# United States Patent and Trademark Office

APPLICATION NO.	FILING DATE	FIRST NAMED INVENTOR	ATTORNEY DOCKET NO.	CONFIRMATION NO.
10/517,055	08/10/2005	Jean-Louis Bougamont	03769-P0011A GSW/TMO 2875	
24126	7590 10/30/2006		EXAMINER	
	STEWARD JOHNST	BOECKMANN, JASON J		
,	986 BEDFORD STREET STAMFORD, CT 06905-5619		ART UNIT	PAPER NUMBER
	, • •		3752	
			DATE MAILED: 10/30/2006

### **DETAILED ACTION**

Examiners Marked up Figure 1

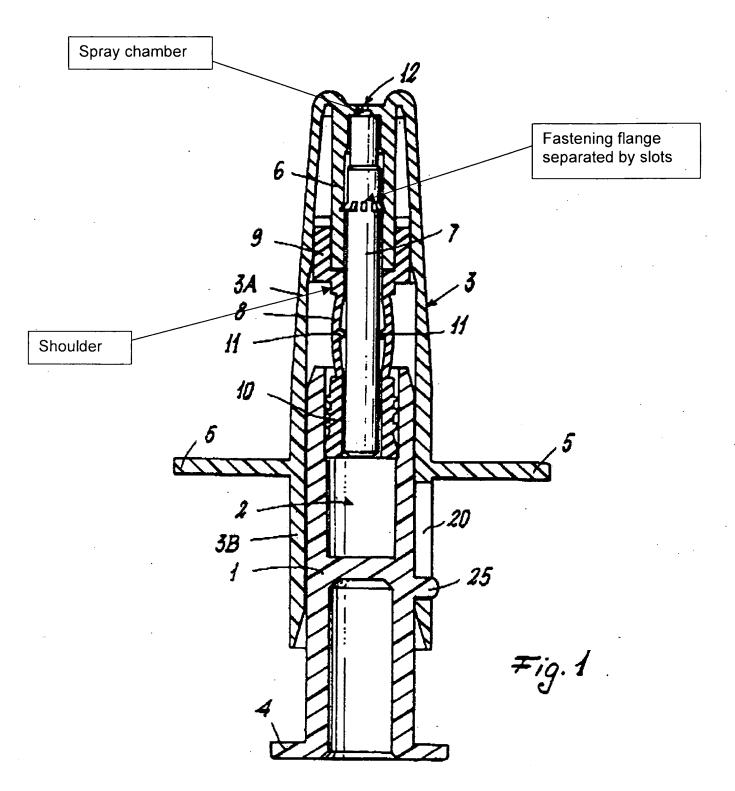
Regarding claim 2, the fastening flange comprises at least one annular flange sector delimited by a slot (see examiners marked up figure 1 below).

Regarding claims 4, 5, and 17-20, the axial core comprises an axial bearing surface (the outer surface) cooperating with the wall of the channel and at least one radially projecting cylinder sector delimited by a slot (see examiners marked up figure 1 below)

Regarding claim 11, the channel comprises a shoulder (see examiners marked up figure 1 below) in the vicinity of the second end of the channel and the core extends towards the second end of the channel beyond the shoulder.
